Device Errata

Skywire[®] Raspberry Pi Adapter

NimbeLink Corp

Updated: July 2017

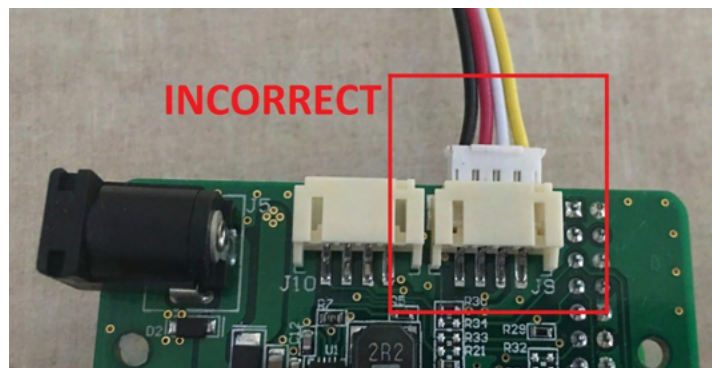
Applications using the Grove connectors on NL-AB-RPI adapter board with PCB revision 1001430 REV A are affected. The grove connector pins are reversed, as shown in the image below. Users who wish to use Grove sensors on affected PCBs must follow the steps outlined in section four of this errata.

Grove sensors using unmodified cables should not be directly attached to the Grove connectors on affected boards as this may cause shorts and/or damage to the sensor or Raspberry Pi.

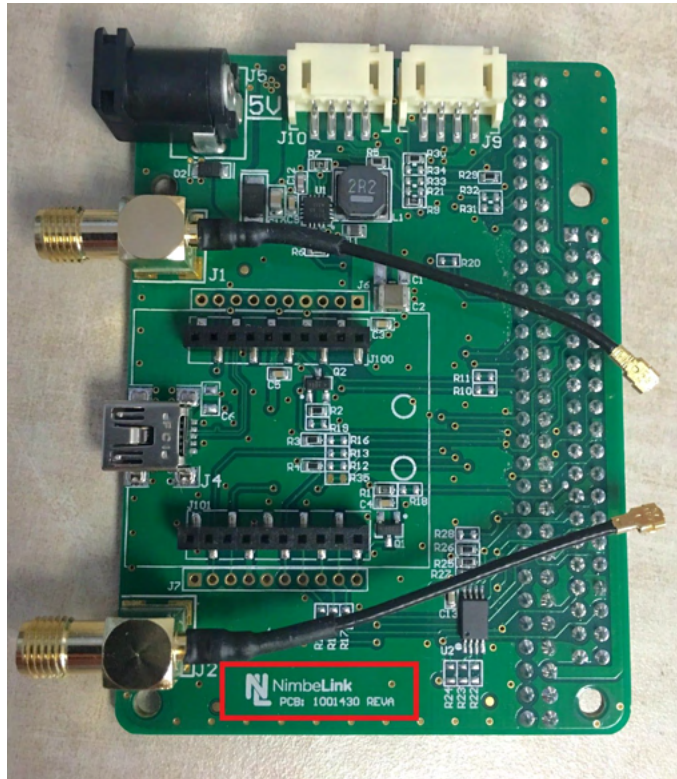
The PCB revision number is located on the bottom of the top side of the PCB. This Errata affects all NL-AB-RPI boards with a PCB revision number of 1001430 Rev A.
